**ADDENDUM NO. 1 TO BID DOCUMENTS FOR THE
EAST MUD LAKE HYDROLOGIC RESTORATION
PROJECT (CS-20) - FINAL MAINTENANCE**

CAMERON PARISH, LOUISIANA

**STATE OF LOUISIANA
COASTAL PROTECTION AND RESTORATION AUTHORITY**

June 18, 2018

Structure #17 - As-builts.

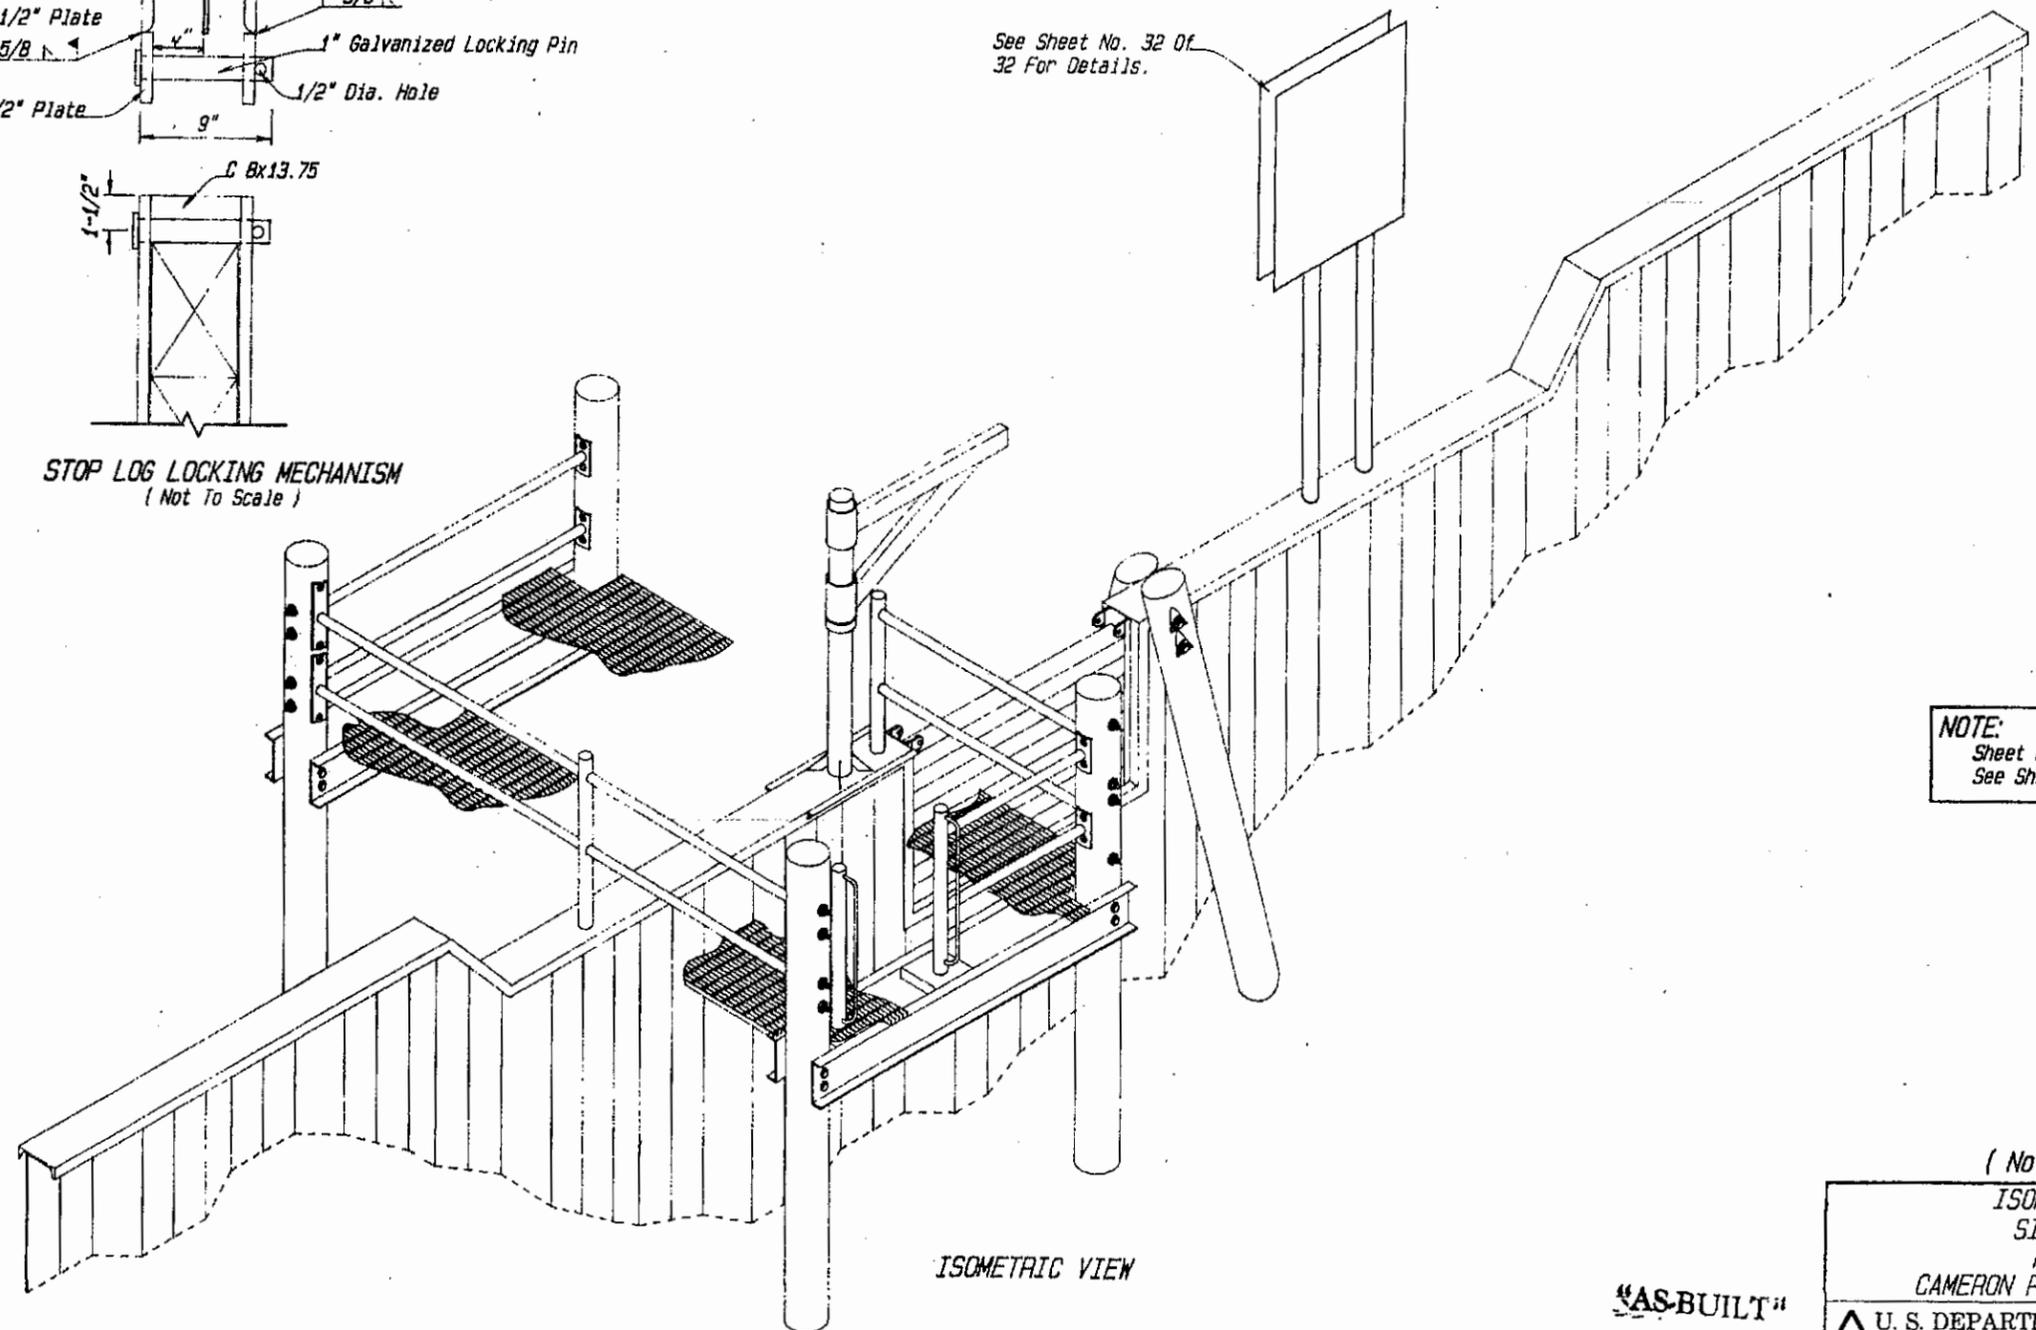
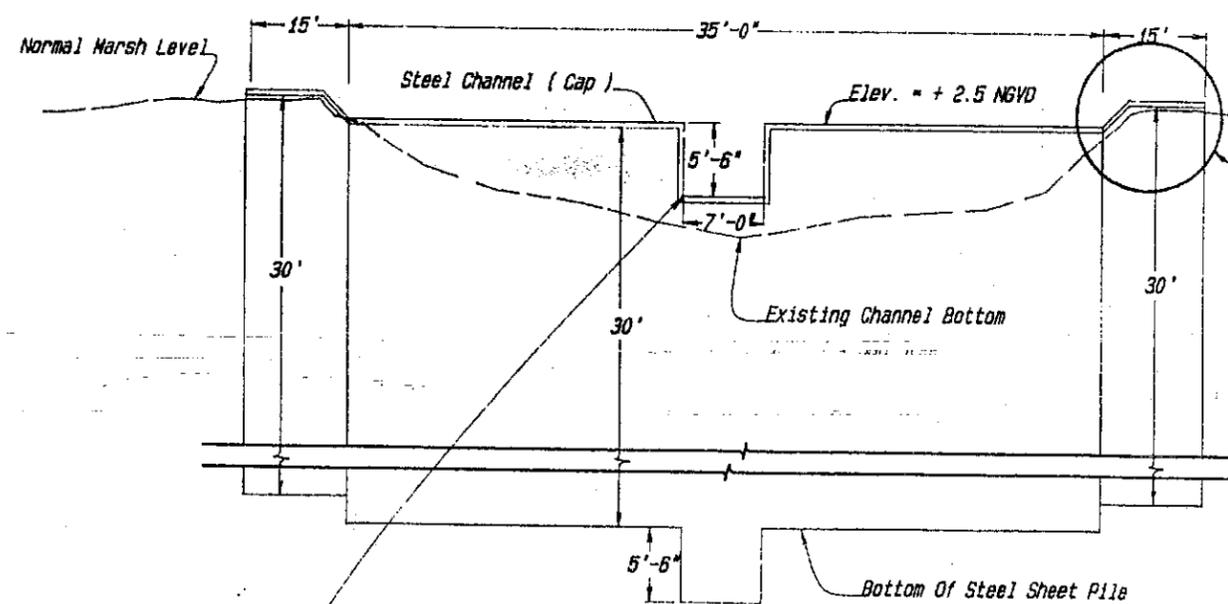
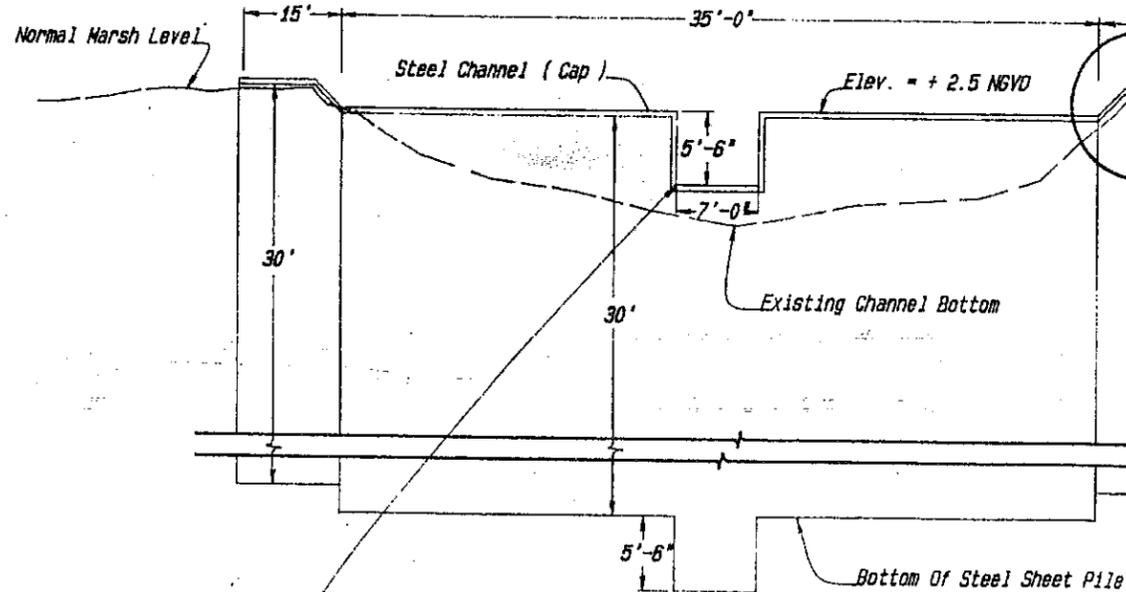
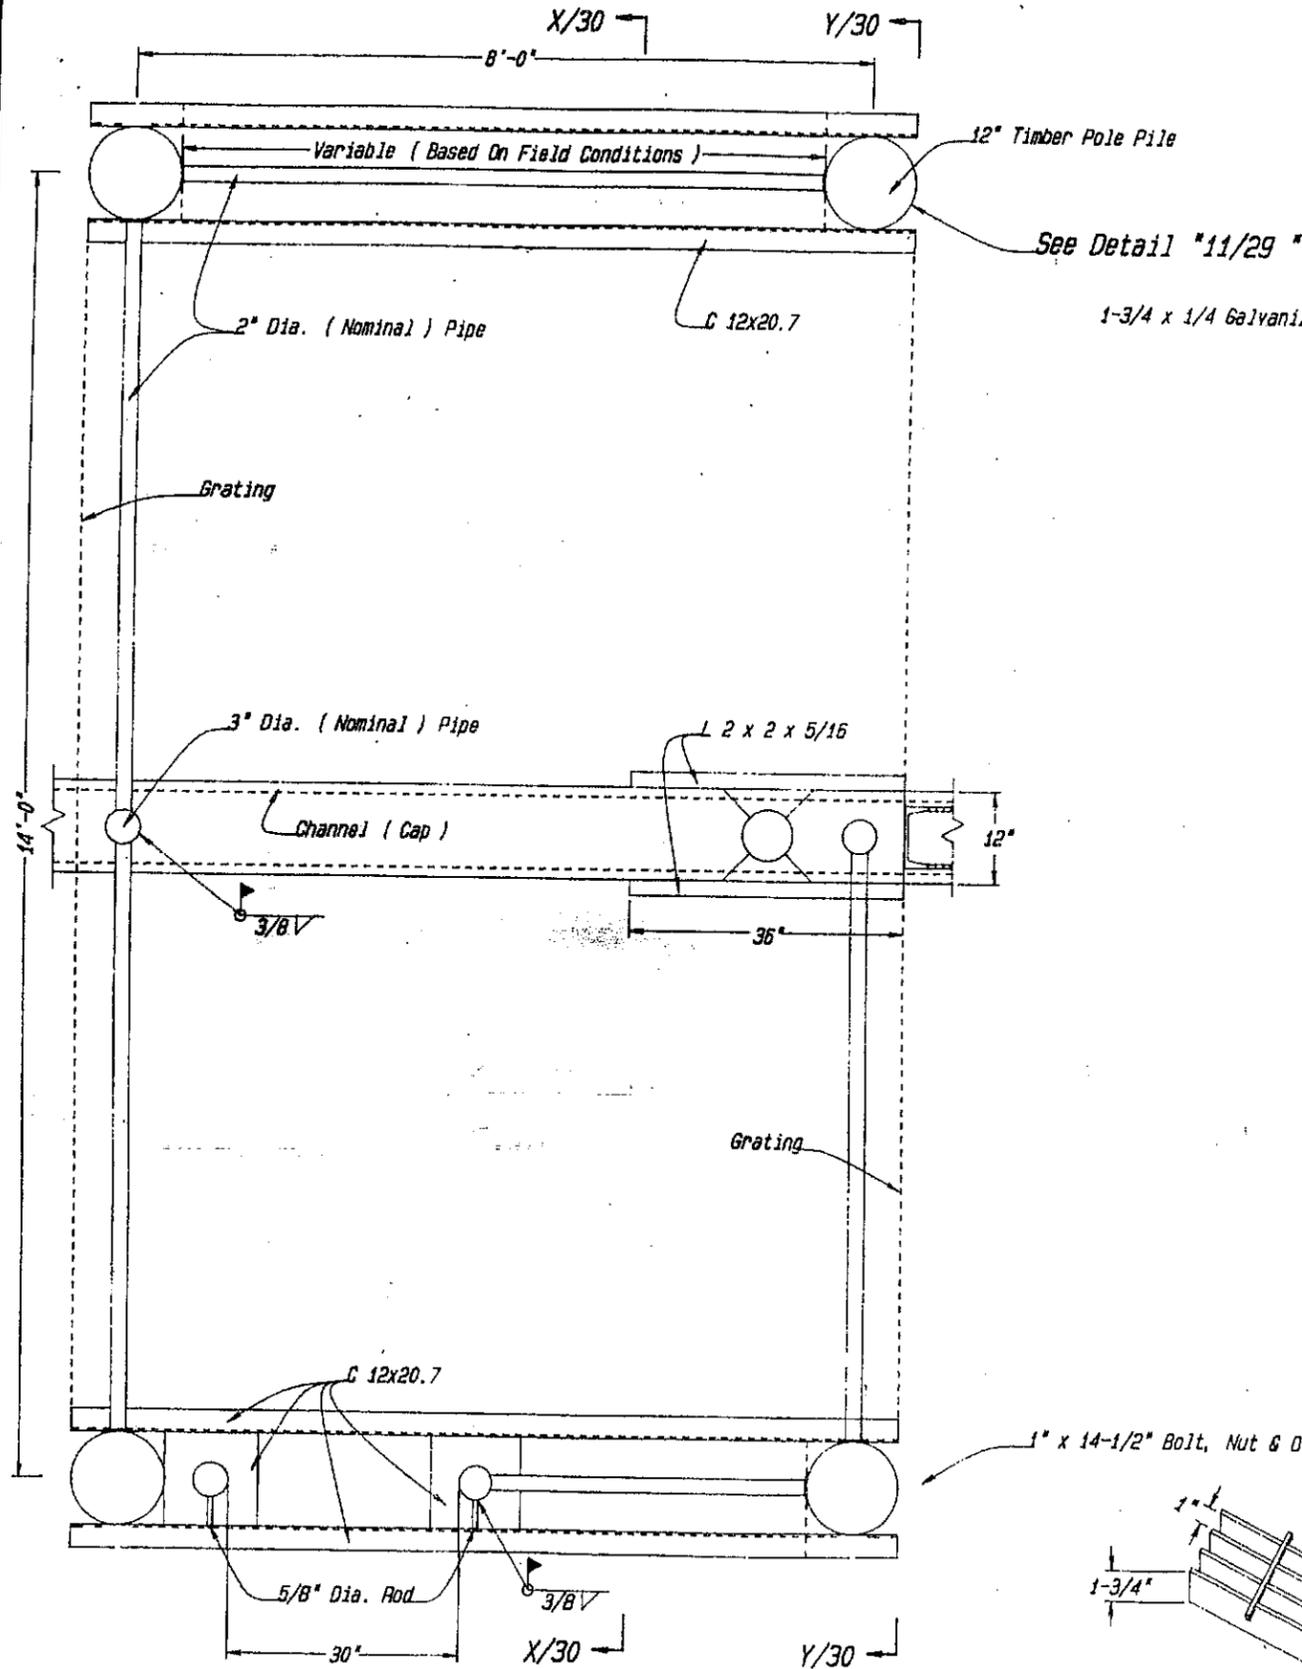
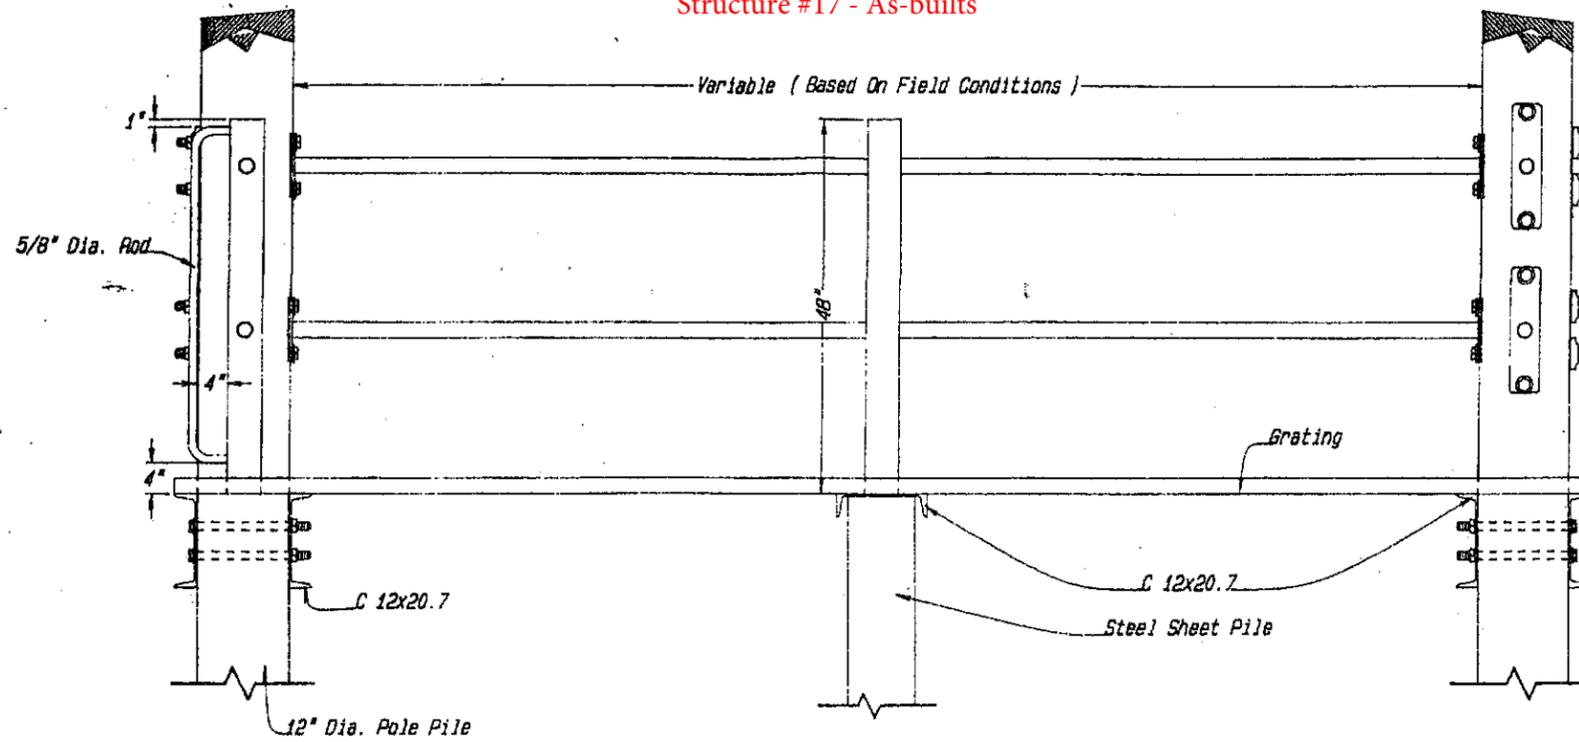
1. Question: Can you provide the construction drawings or as-built drawings for the existing Structure No. 17 for the purpose of aiding in the estimating of demolition of the structure?

Response: See attached drawings.
